Site Instruction

SI 20

PROJECT : **Hampton Manor**
PROJECT No : 1136.13
DATE : June 14, 2018

Title: Mechanical Floor Precast Update

1:100 A401b

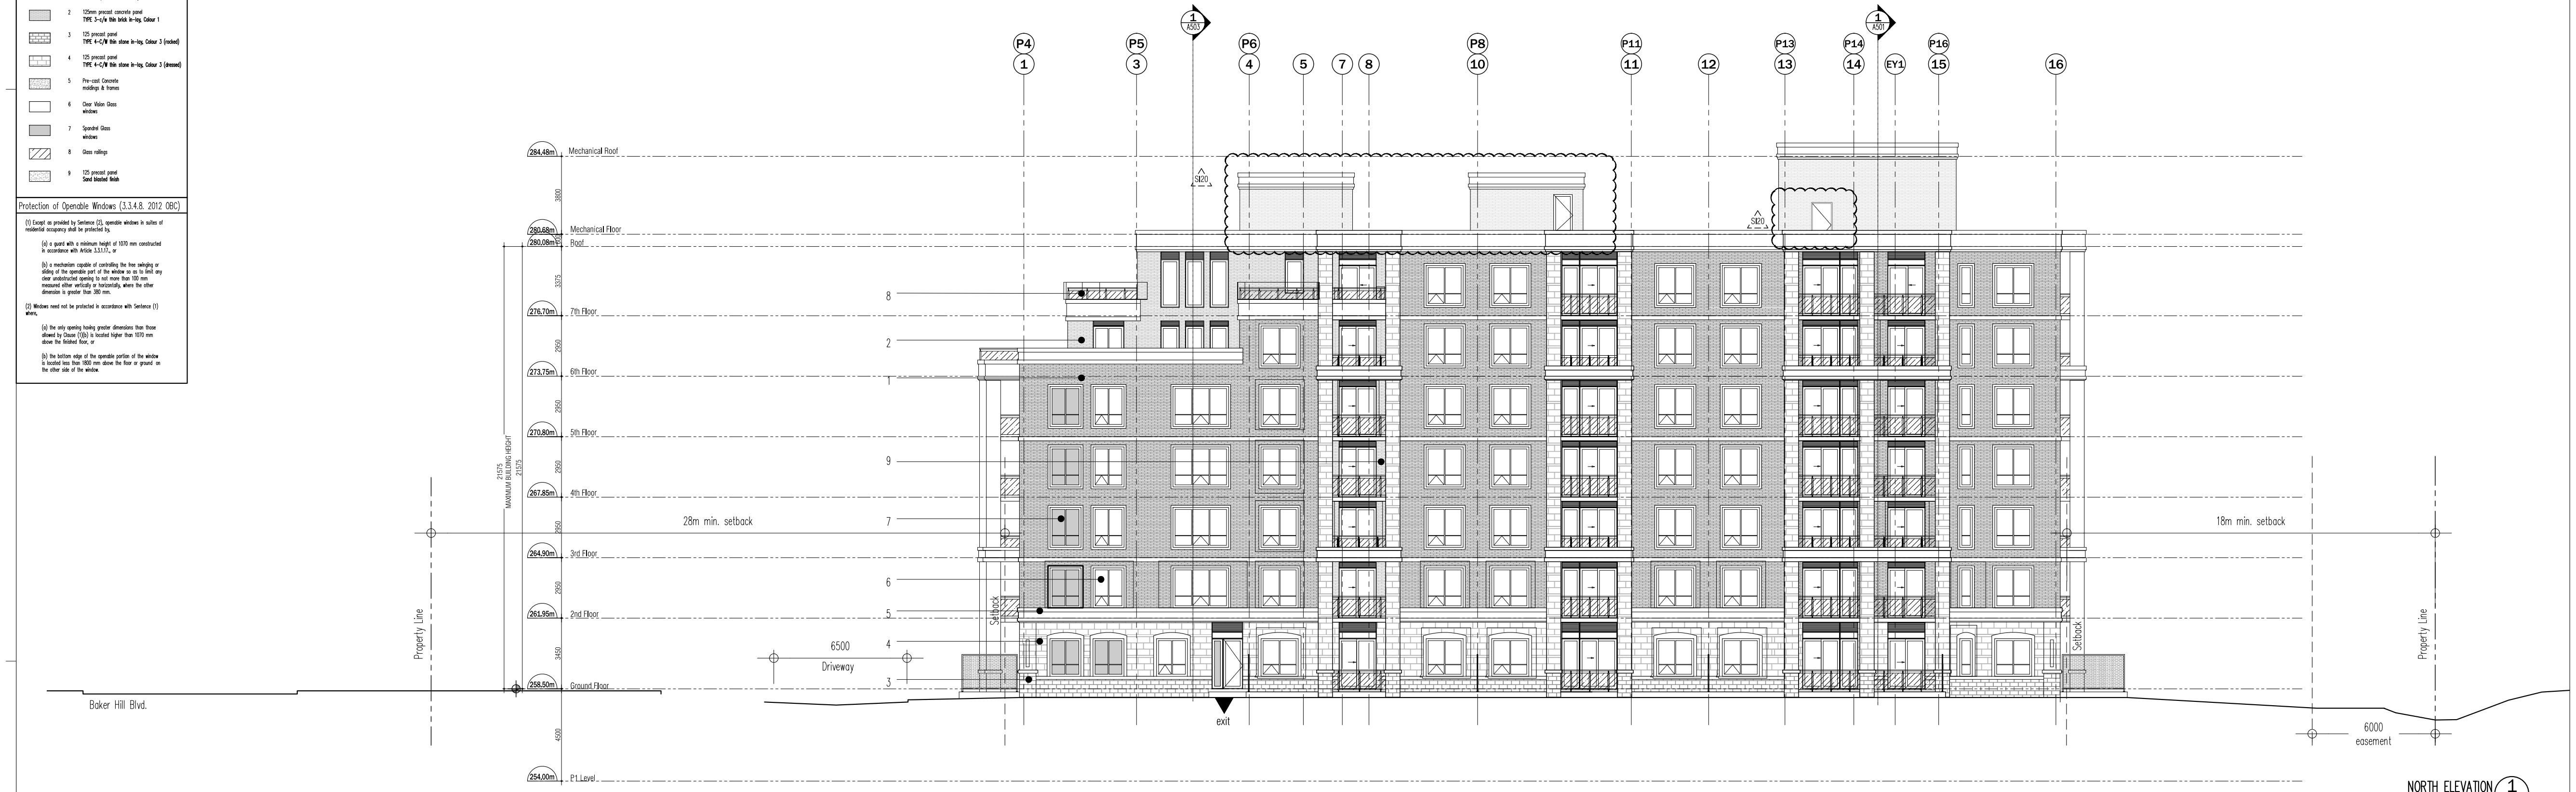
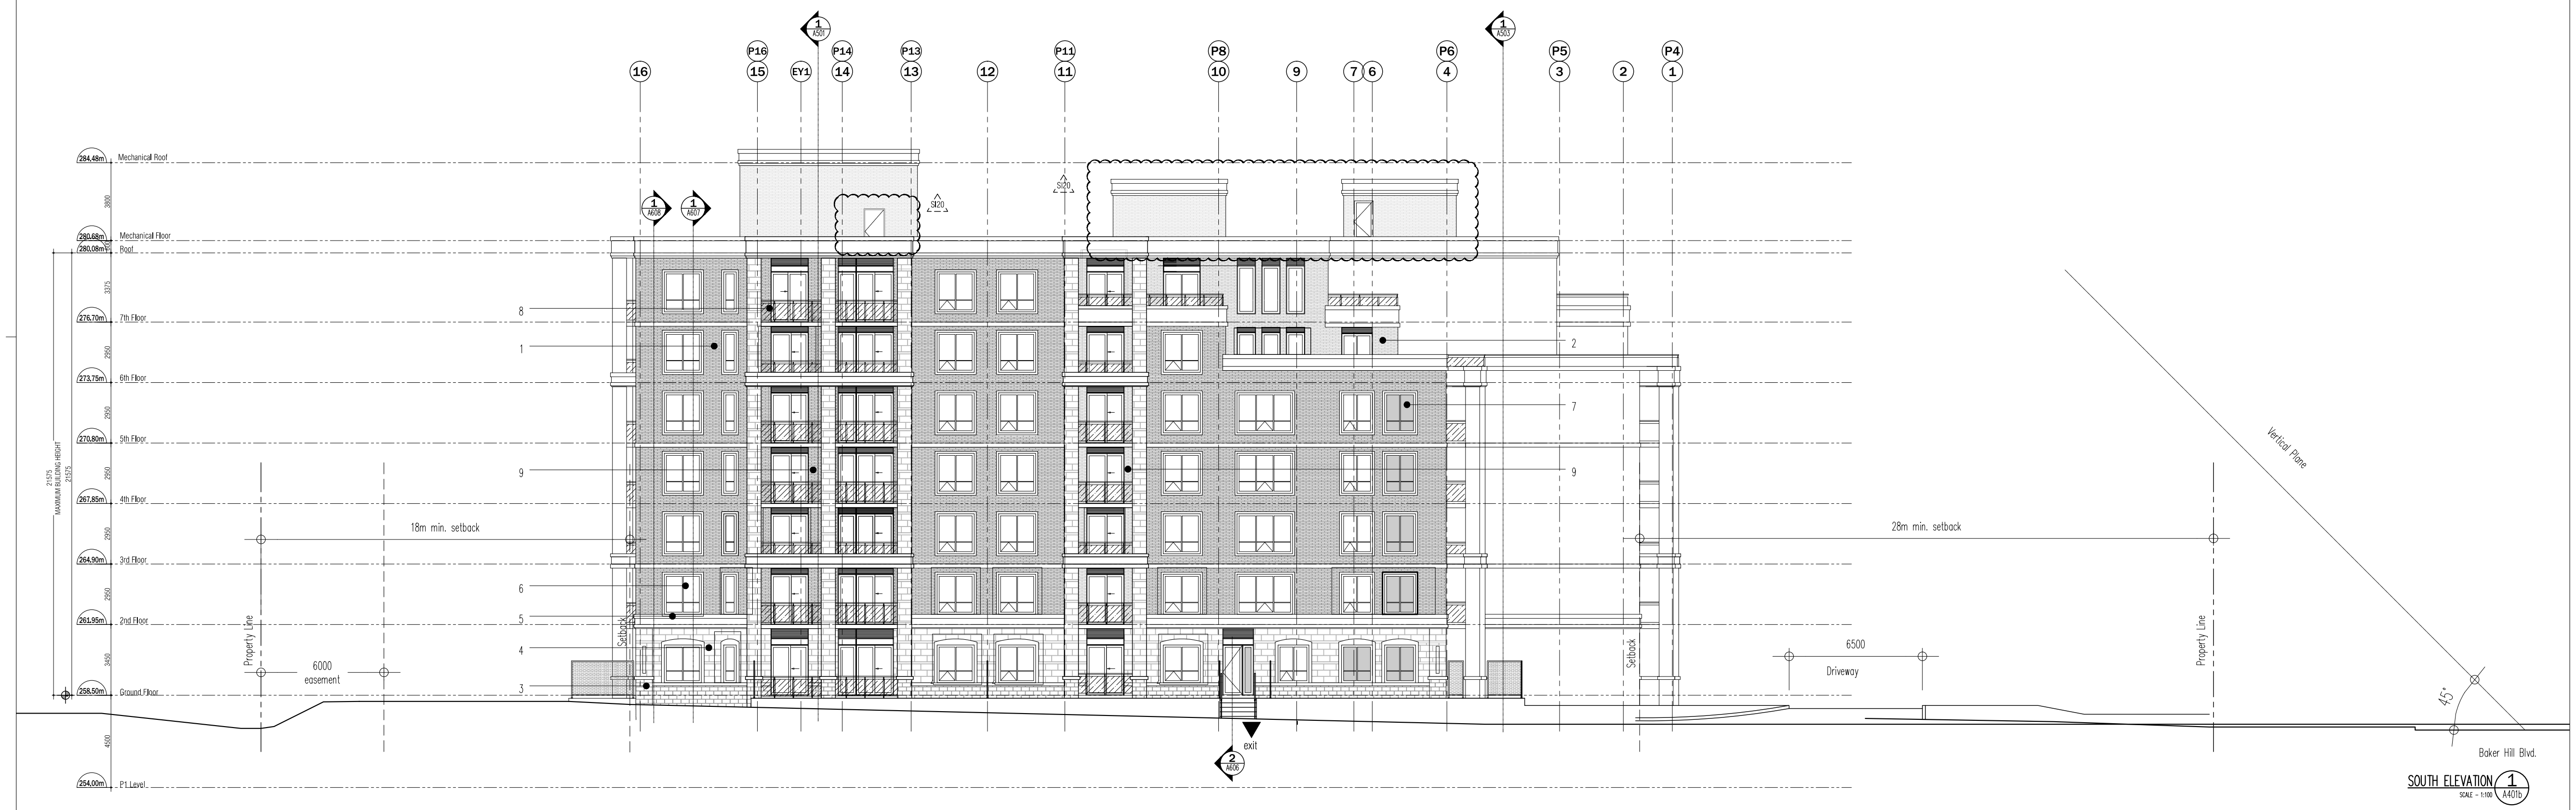
A401a, A401b, A401c – Building Elevations
- Showing louvers on Mechanical Penthouse and revising spandrel cladding to precast at stair A & B.

1:100 A502

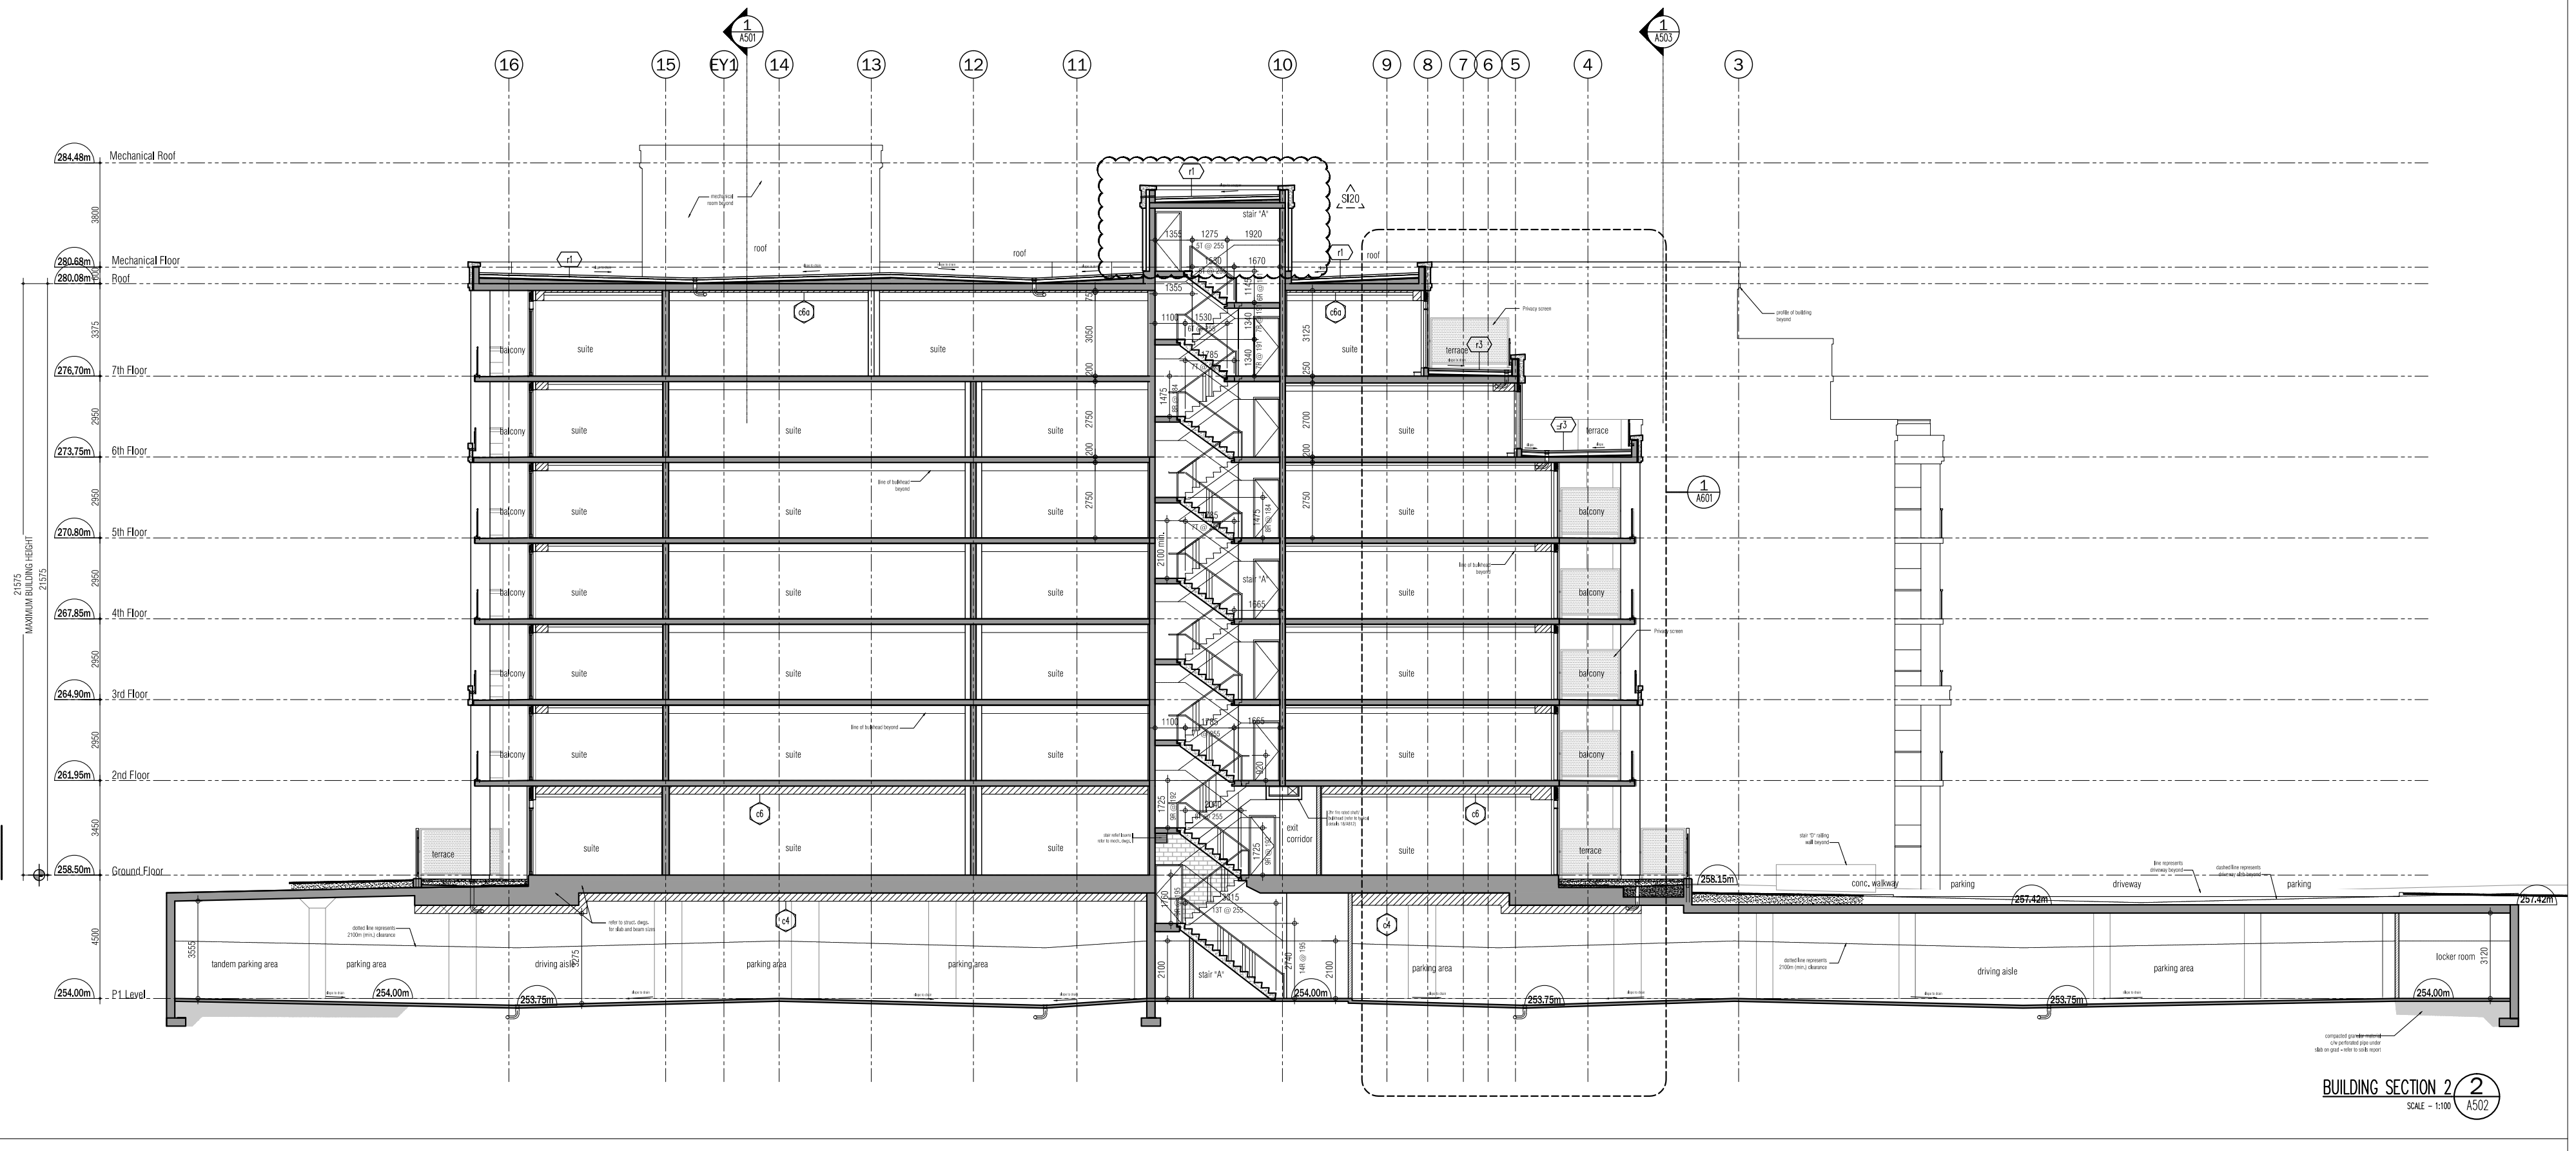
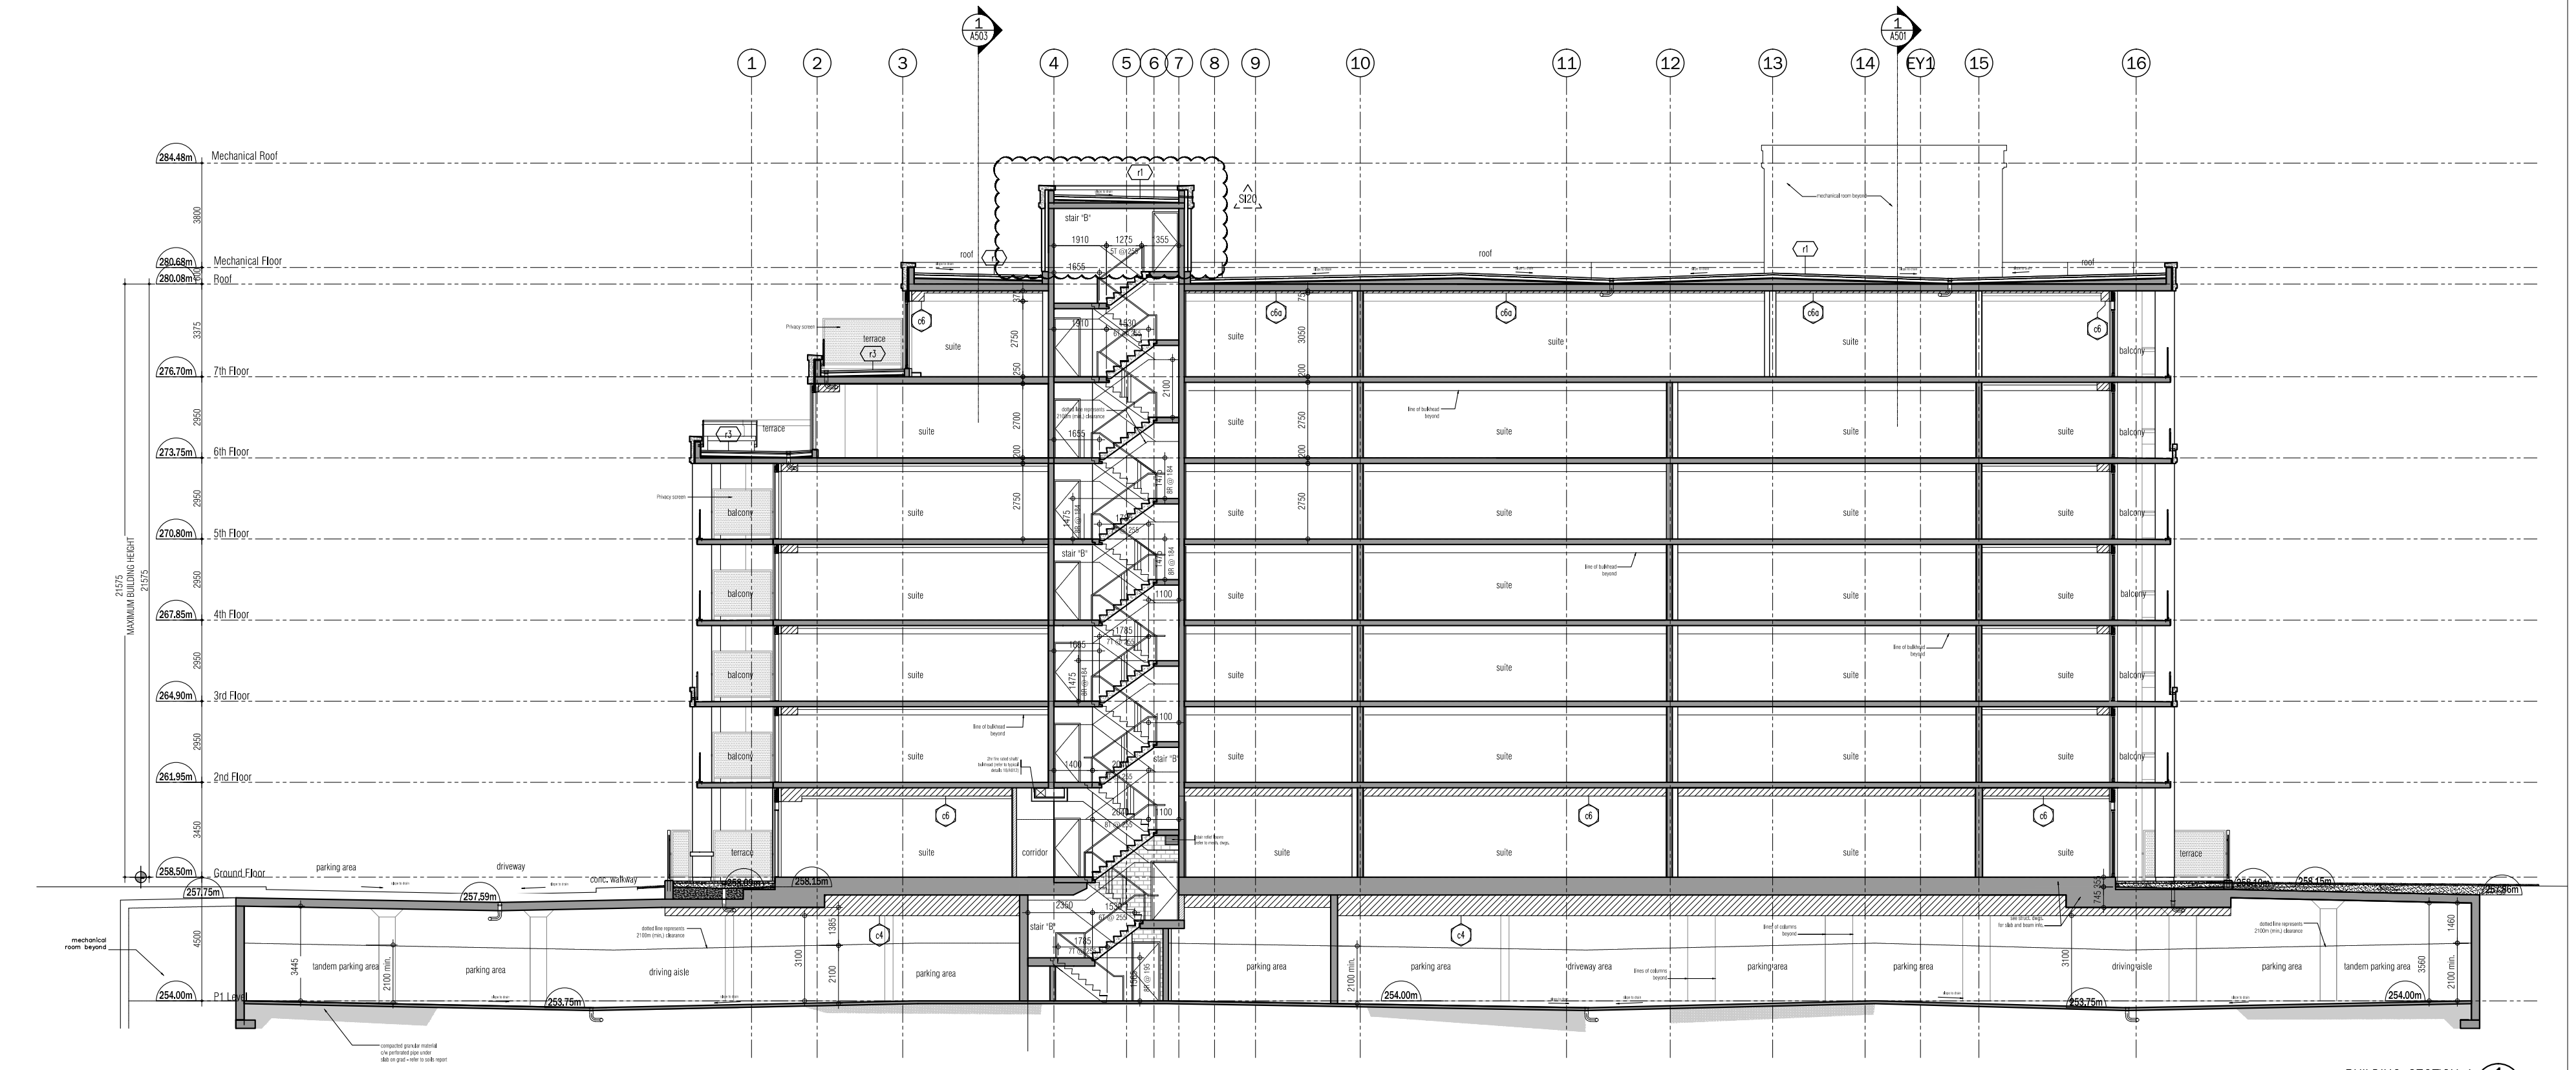
A502 – Building Sections
- Revising spandrel cladding to precast at stair A & B.
